31st May 2018

LETTER OF OBJECTION TO SSD APPLICATION 8669 ST ALOYSIUS COLLEGE REDEVELOPMENT

Urban Concepts has been engaged by Mr and Mrs Copley, the owners of Apartment 2 in Craiglea House at 49 Upper Pitt Street, Kirribilli to prepare an objection to the aforementioned SSD Application.

ARTIST'S IMPRESSION OF UPPER PITT STREET AERIAL VIEW

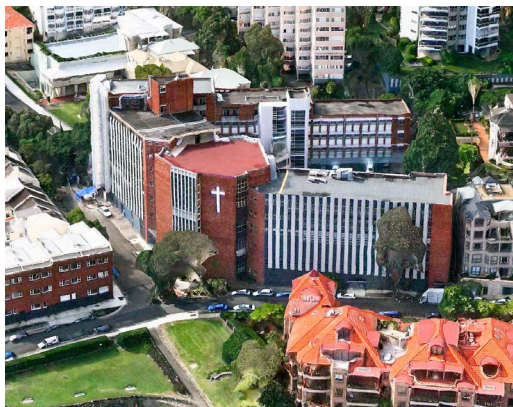
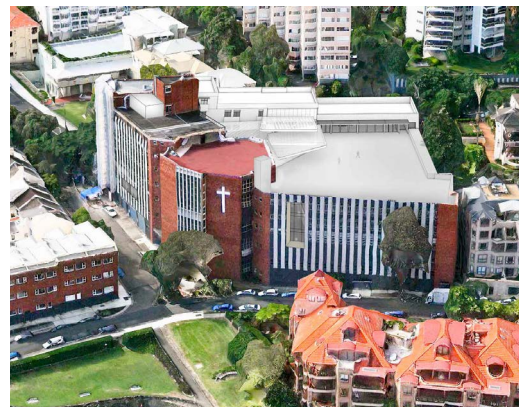
The Request for SEAR's does not address the heritage significance of Craiglea. The design response being advanced for the Middle Campus infills the quadrangle providing a minimum setback and an imposing vertical wall along the eastern boundary. This design response indicates that little consideration has been given to the heritage setting of Craiglea House and its garden curtilage.

At the consultation events it was suggested by the St Aloysius project team that a rooftop playground would improve acoustic privacy for Craiglea residents however this proposition was not supported by any technical investigation. The current change in ground level between Craiglea and the Middle Campus combined with the landscaping along the school's eastern boundary mitigates the visual impact of the existing quadrangle playground. Refer Photograph 5. Raising the playground and increasing its size to cover the entire rooftop of the middle campus will have an overbearing visual impact on Craiglea and detrimentally alter the acoustic environment as well as the views and vistas currently enjoyed from the Upper Pitt Street public domain. Refer Photographs 6 and 7.
